PLANNING AND ZONING DEPARTMENT

PLANNER'S REPORT

DATE: May 8, 2019 TO: Tonya Hutson Kev: FROM: Lynn M. Patterson Compliant: Not Compliant: Incomplete: RE: Design Review - 3472 Rainey Avenue Not Applicable: 0

LEFT ELEVATION

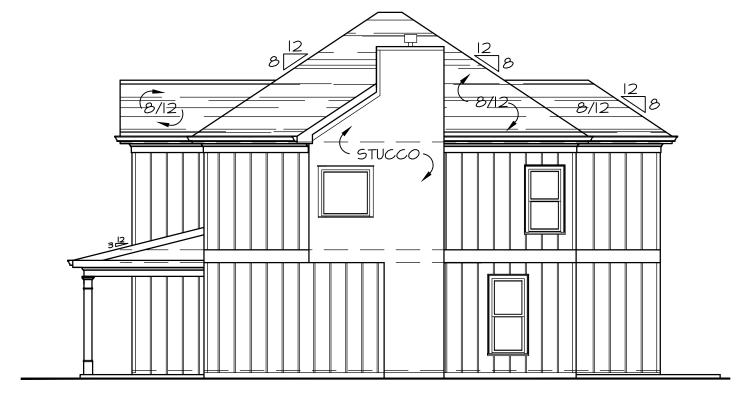
The first floor of the left elevation is windowless, which is inconsistent with the windows shown on the floor plans and is not

The first floor of the left elevation is windowless, which is inconsistent with the windows shown on the floor plans and is not permitted.

FRONT ELEVATION

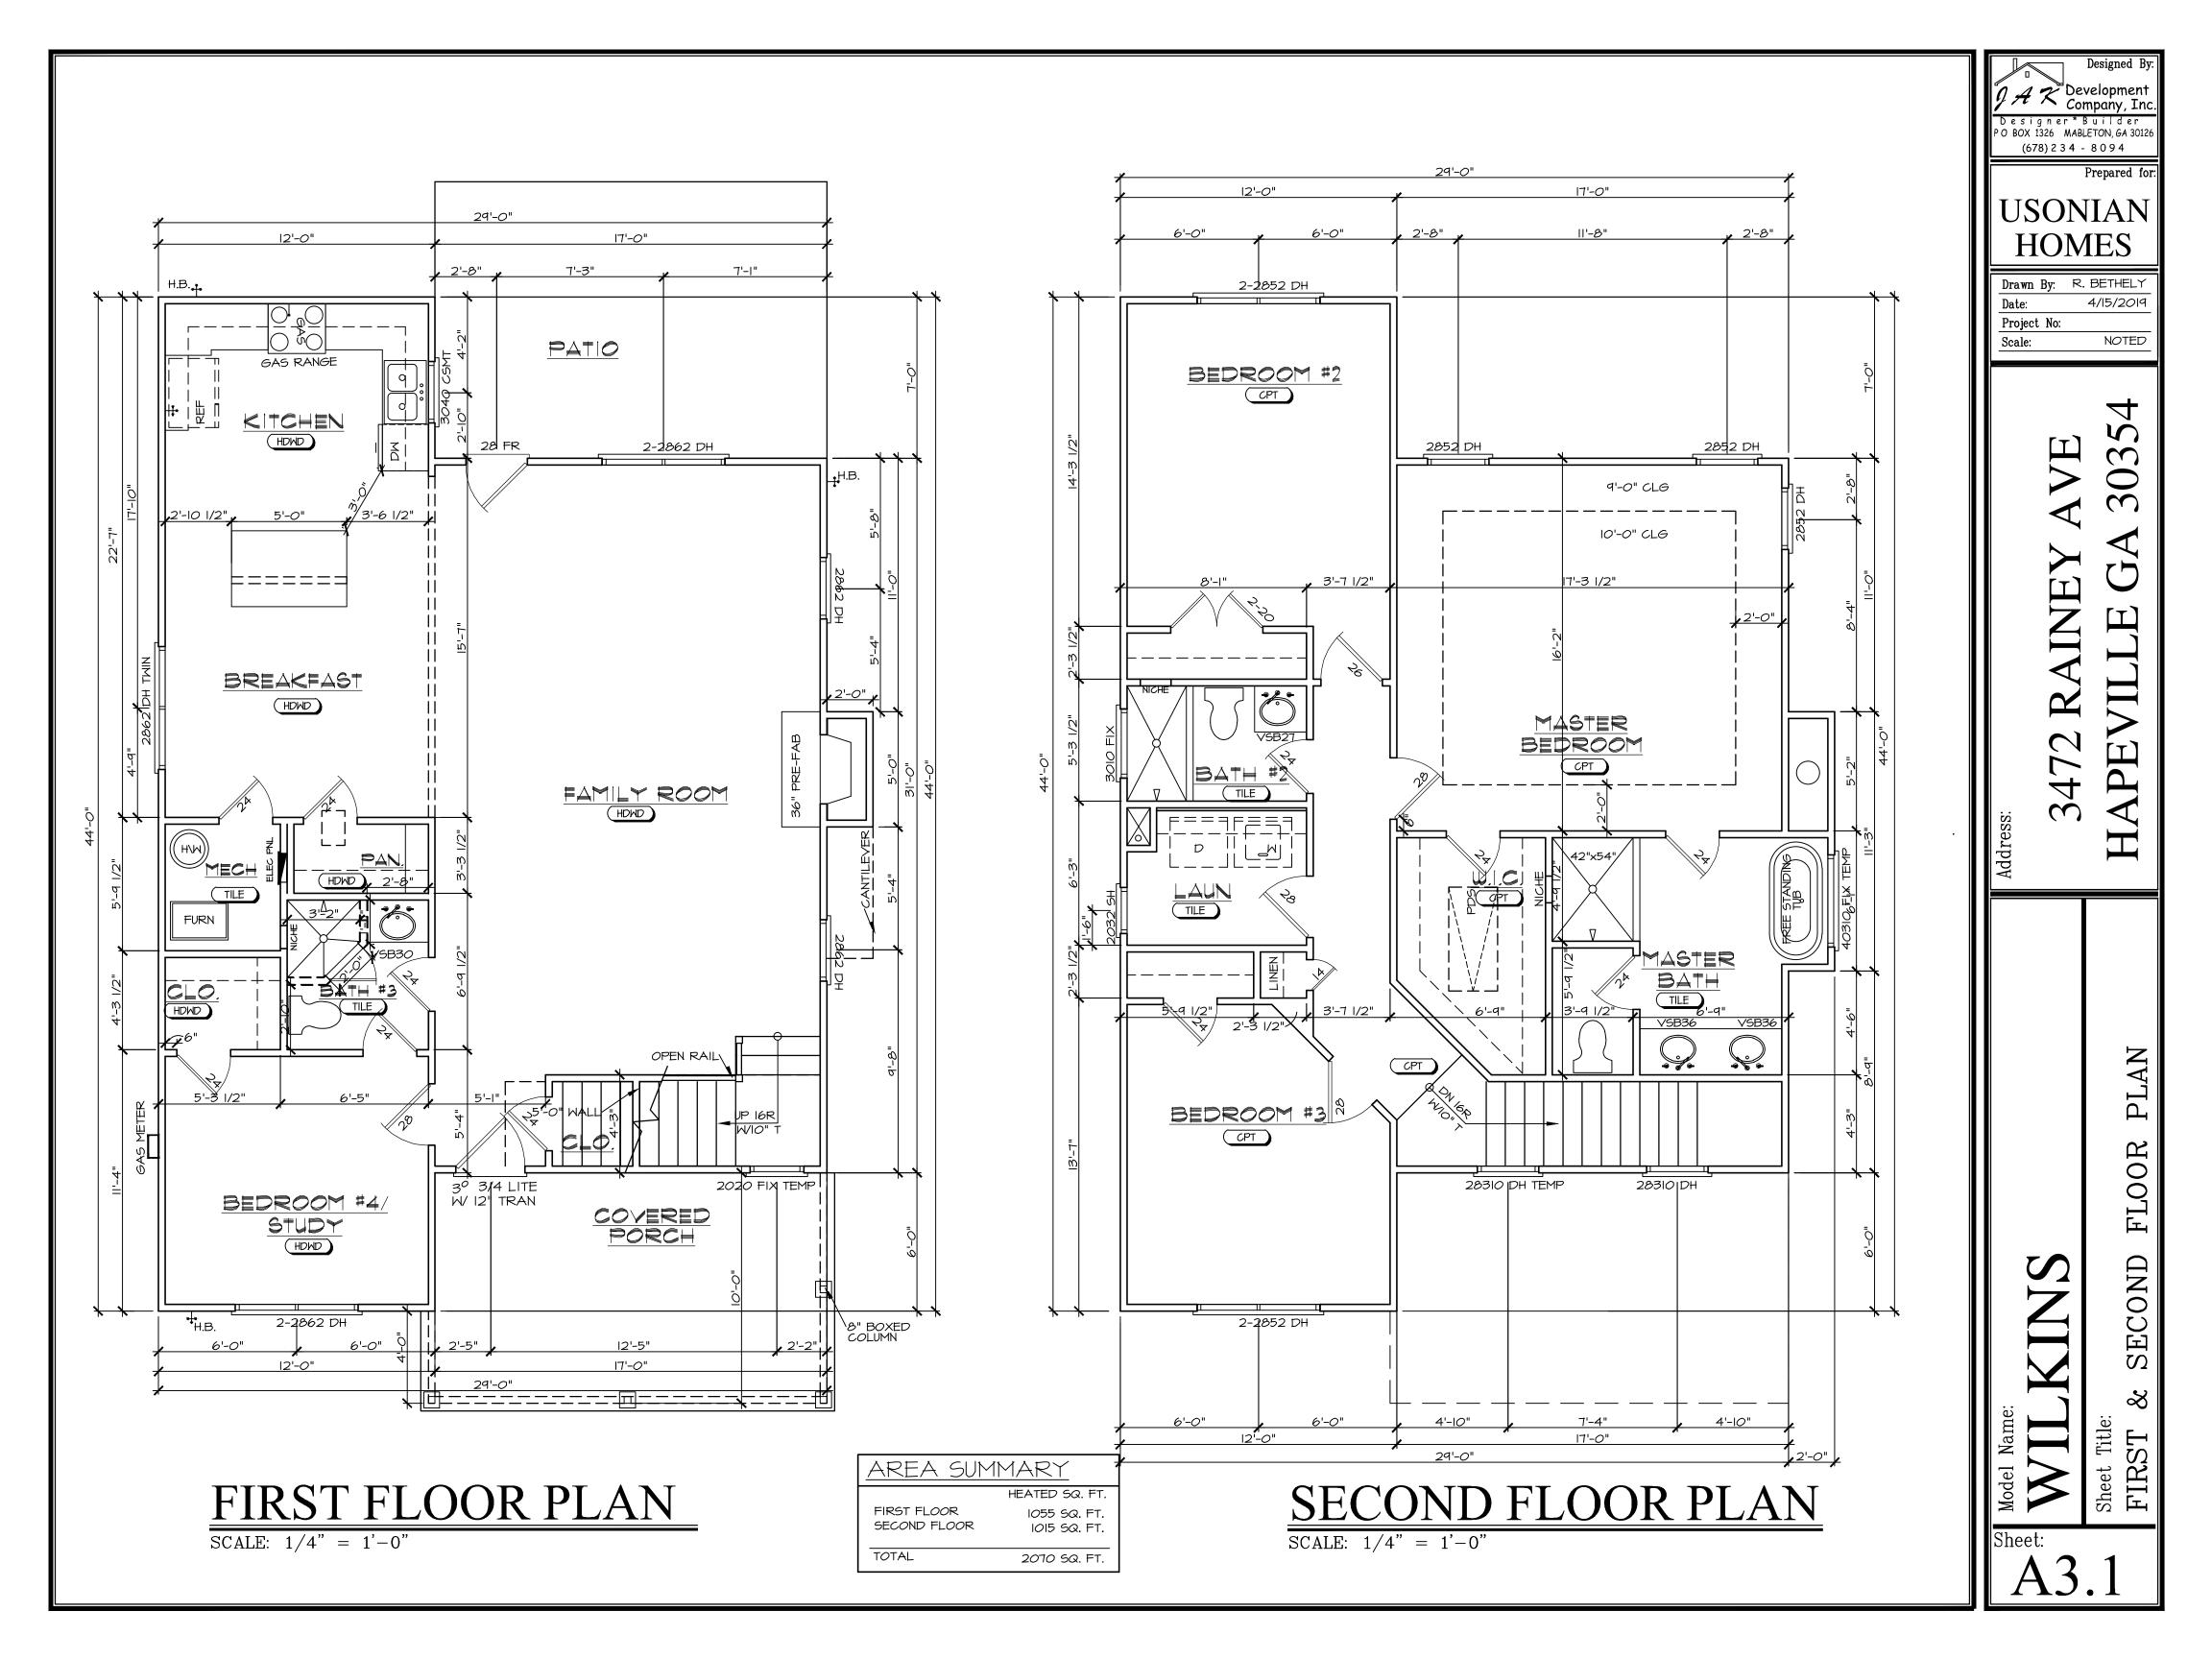
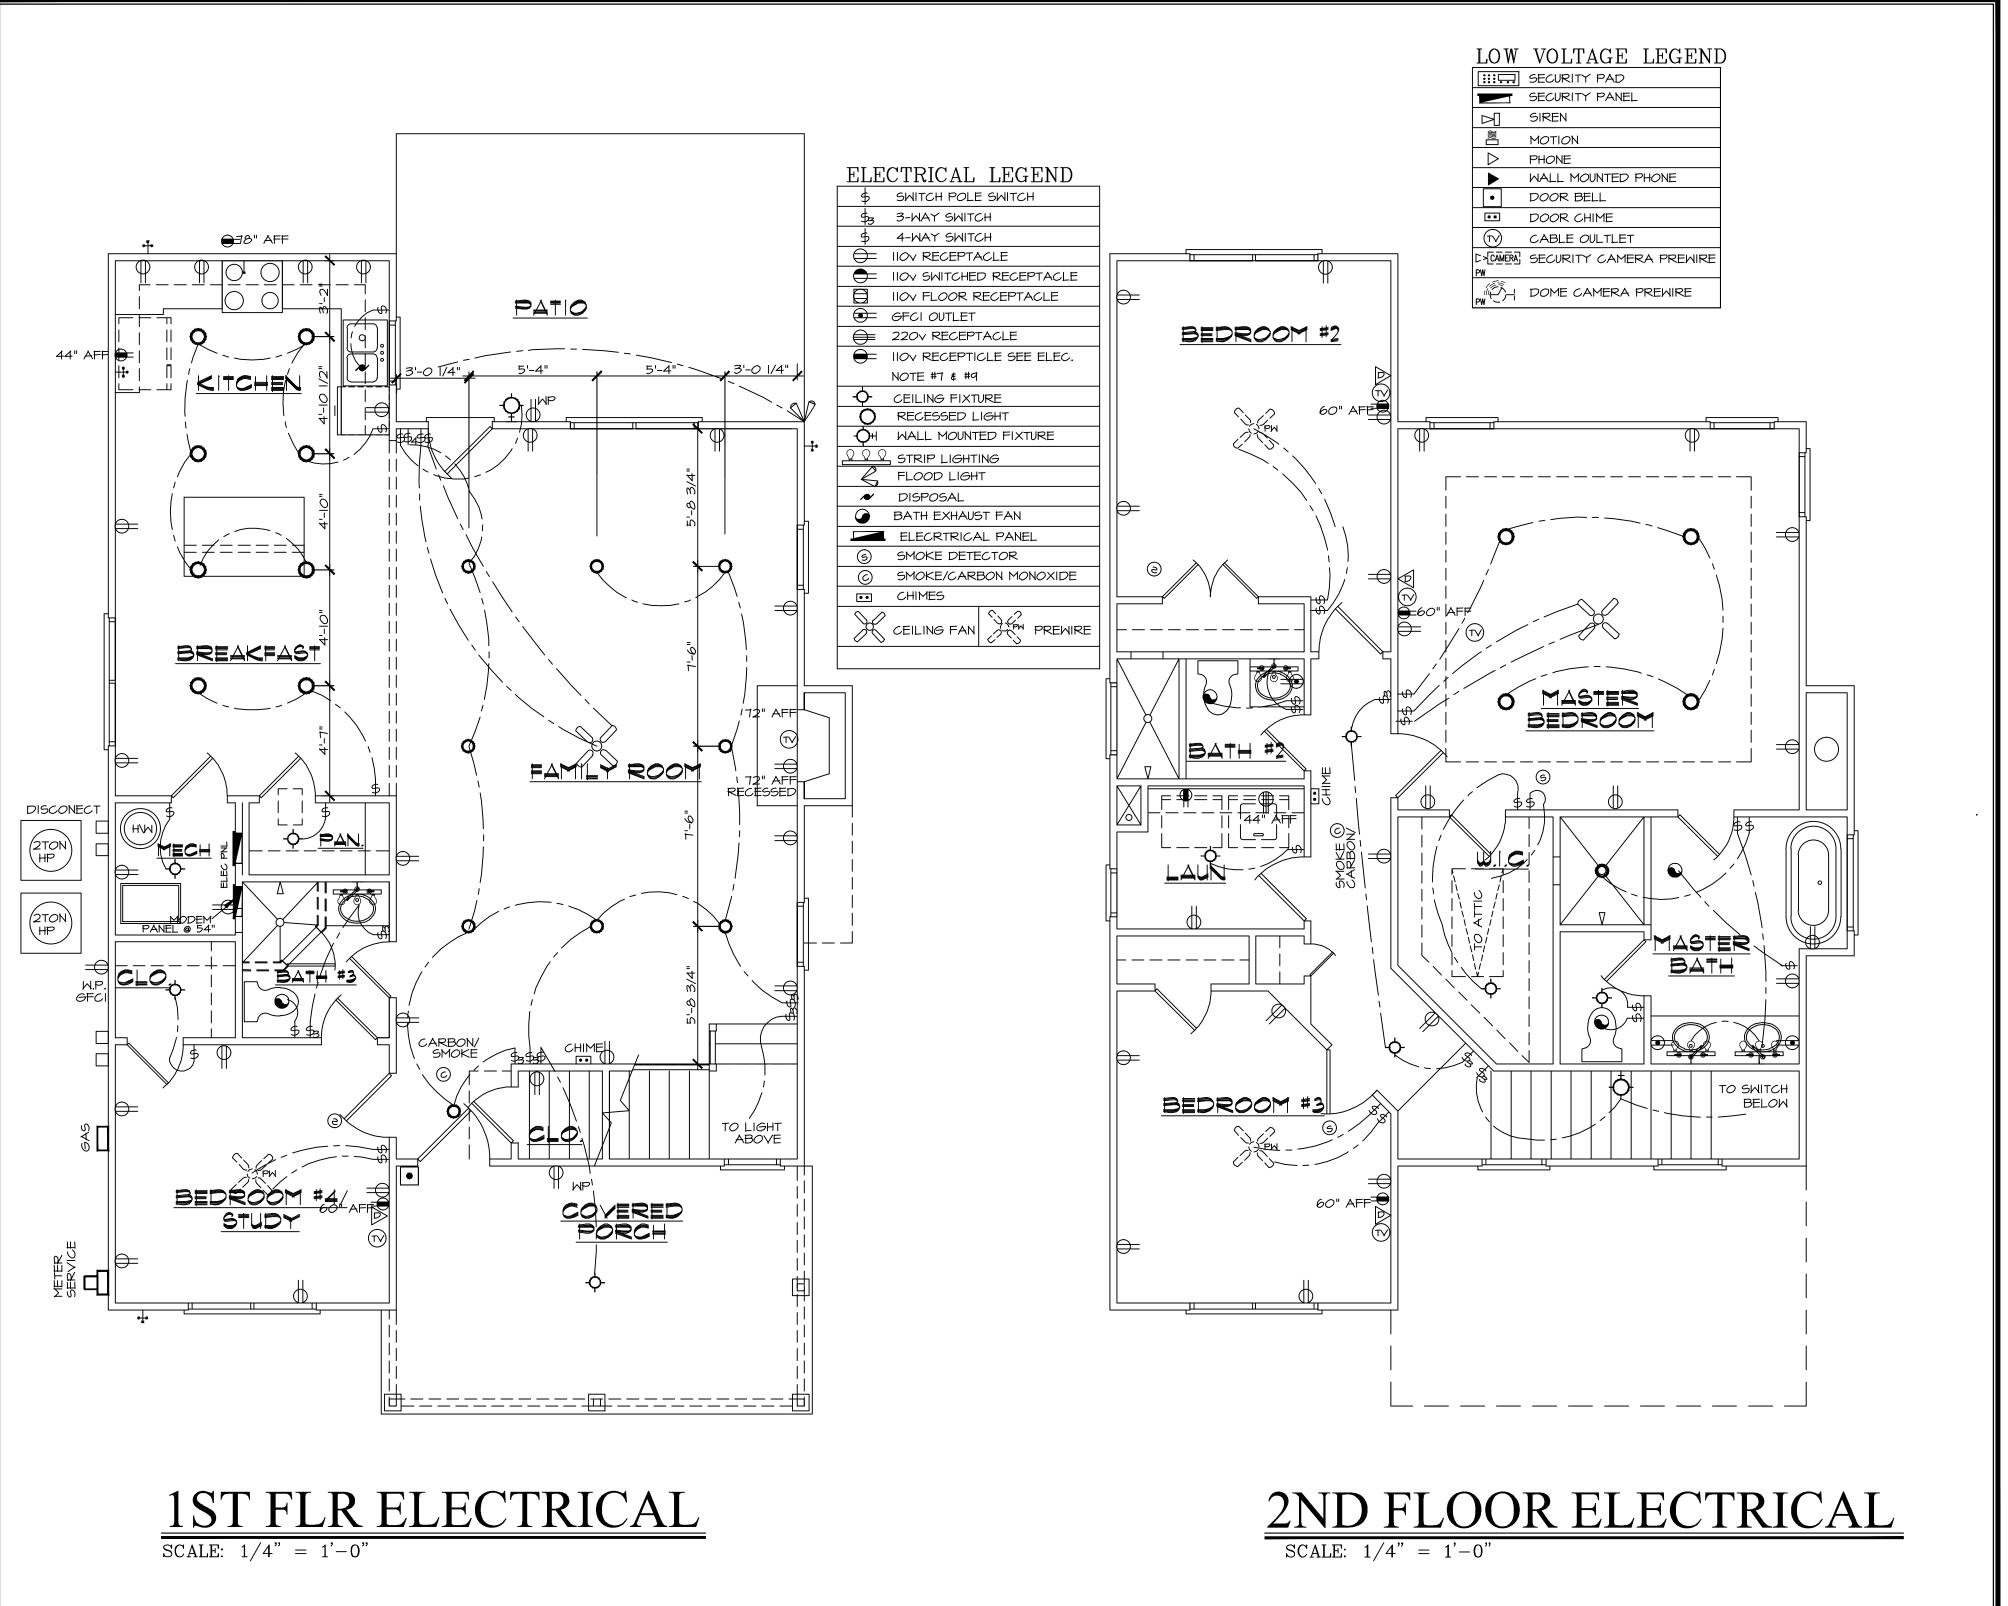
STAFF COMMENT: The use of PVC columns on the porch is not permitted.

The porch width is 59% of the front façade, which is not compliant.

There are no building numbers adjacent to the front door.

The porch width is 59% of the front façade, which is not compliant.

There are no building numbers adjacent to the front door.
